## MEMORANDUM

**Re:** **A&K Jersey Construction of NJ, LLC**  
ZBA Application Z-22-012  
Bulk Variances  
Block 157, Lot 22  
64 West 31<sup>st</sup> Street  
R-2 – Detached/Attached Residential District

**Date:** June 3, 2024

Portion of Sheet 38 of the Tax Map of the City of Bayonne Containing Block 157

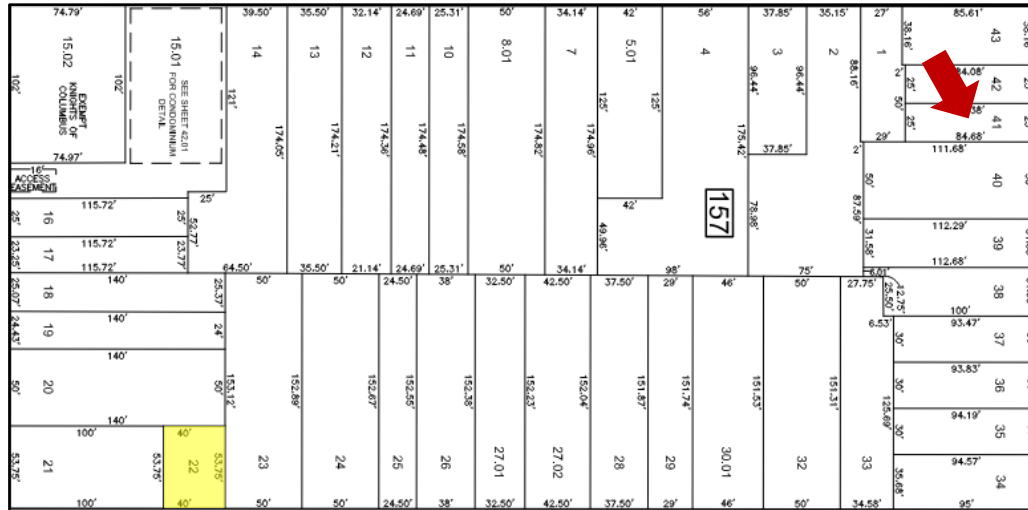
As indicated in the following image of Sheet 38 of the Tax Map of the City of Bayonne (subject lot indicated in yellow), the lot has considerably less depth than every other lot within Block 157. It has the least amount of lot area on W. 31<sup>st</sup> Street between Avenue C and J.F.K. Boulevard, and is the third smallest lot by area within Block 157. The lot has been this size since at least February 1<sup>st</sup>, 1950, pursuant to the Hudson County Register (Book 2397, Page 248) which contains the 1950 deed. The 1950 deed states that the “*same premises conveyed...by deed dated November 10, 1928, recorded November 14, 1928 in the Hudson County Register’s office in book 1694 of Deeds, at page 446*”, though the 1928 deed is unavailable for review. As such, obtaining variances for preexisting conditions relating to the lot dimensions that perhaps exist from before the City’s first Zoning Ordinance, would provide the property owner with a Resolution legalizing the nonconforming conditions.
